Subject: Three Mile Island Nuclear Generating Station, Unit 1 (TMI-1)  
Operating License No. DPR-50  
Docket No. 50-289  
Thermo-Lag Response to Request for Additional Information

NRC letter dated November 20, 1996 (6710-96-3408) requested additional information regarding the TMI-1 request for exemption from 10 CFR 50 Appendix R, previously submitted by letters dated August 16, 1996 (6710-96-2229) and August 28, 1996 (6710-96-2301). The attachment provides an itemized response to each of the NRC questions.

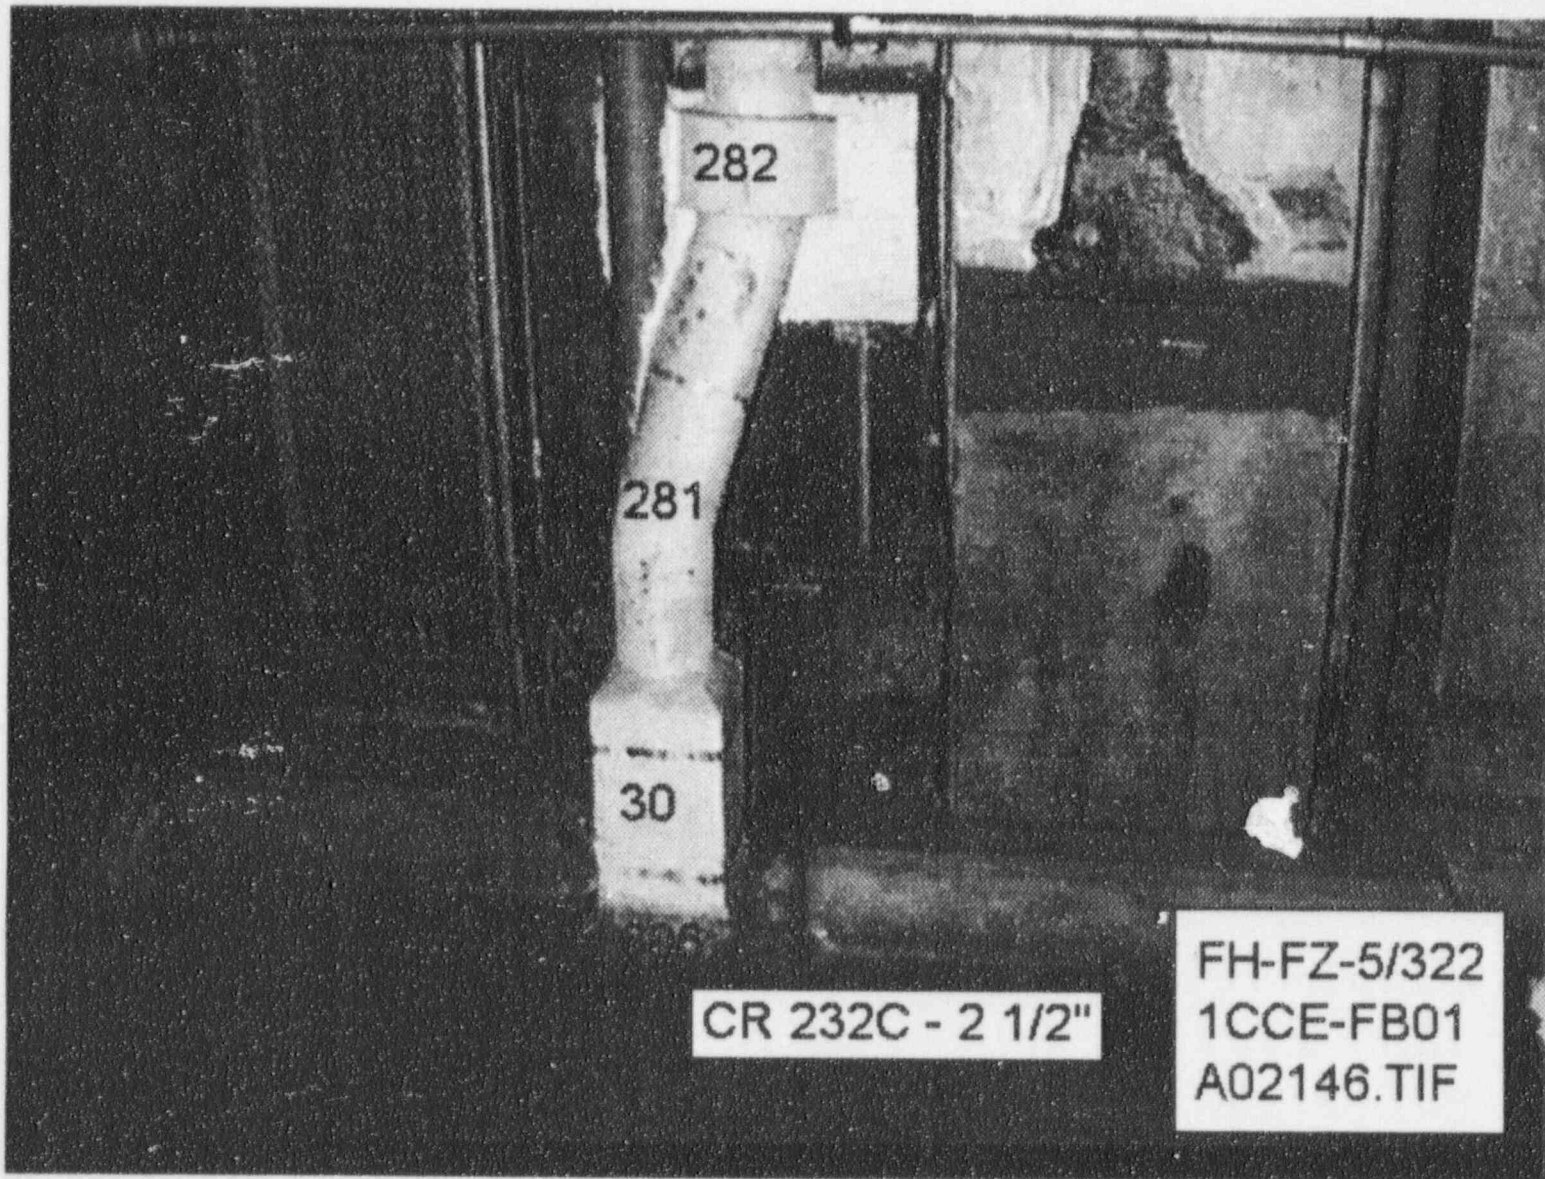
7. The following elements are listed as penetrations in Attachment 1 to Topical Report #094: 31, 573, 574, 582, 577, 578, 545, 605, and 606.

The NEI program did not test penetrations, and it is not clear from the evaluation of these elements how they are bounded by the fire tests that were discussed. Please clearly describe the configurations of these individual elements, as they are installed in the plant. Detailed drawings should be provided for further clarification. In addition, describe how these elements are bounded by the fire tests discussed in the evaluation.

The elements in question constitute elements which GPU Nuclear believes are adequately supported by NEI testing with respect to similarities in the construction of the interface point of Thermo-Lag fire barrier envelopes and the walls. Photographs of these elements are attached for information. Note that a photograph of Element 573 is not available; however, its configuration is as described below. We have modified how we designate these configurations in our electronic data base based upon our conference call of December 4, 1996. These configurations are now referred to as penetration interfaces in lieu of penetrations.

Element 31 is similar to the interface of all three conduits (6", 3", 3/4") in NEI Test 2-3 with the test deck. The NEI configuration extended the test item with 1"-thick preformed Thermo-Lag through the test deck and sealed around the outside of the barrier with silicone foam at the opening through the test deck. The only difference between the tested configuration and Element 31 is that in the test, ceramic insulation was installed on the underside of the test deck instead of bare concrete which is the case for Element 31. The construction of Element 31 is the same inside the penetration as inside the test deck, and silicone foam is commonly used as a penetration seal and has been tested successfully as a one-hour seal. This provides confidence that the GPU Nuclear configuration is a one-hour fire barrier. The NEI test, although not identical in configuration, provides additional level of confidence that this configuration is acceptable.

Elements 573, 574, 582, 577, 578, 545, 605 and 606 consist of interface joints at concrete walls where Thermo-Lag terminates at the wall and is joined to the wall by pre-buttering the end of preformed Thermo-Lag with trowel grade and attaching to the wall or installing a "picture frame" on the wall and abutting the end of a preformed panel to the picture frame as in Element 545. NEI Tests 3-1 and 3-2 used similar interface joints which were not the cause of the test failures. Therefore, it is concluded that a pre-buttered Thermo-Lag to concrete interface joint is not a potential weak link and has been shown to provide protection for at least 60 minutes for 1"-thick Thermo-Lag based upon the results of the aforementioned NEI tests.
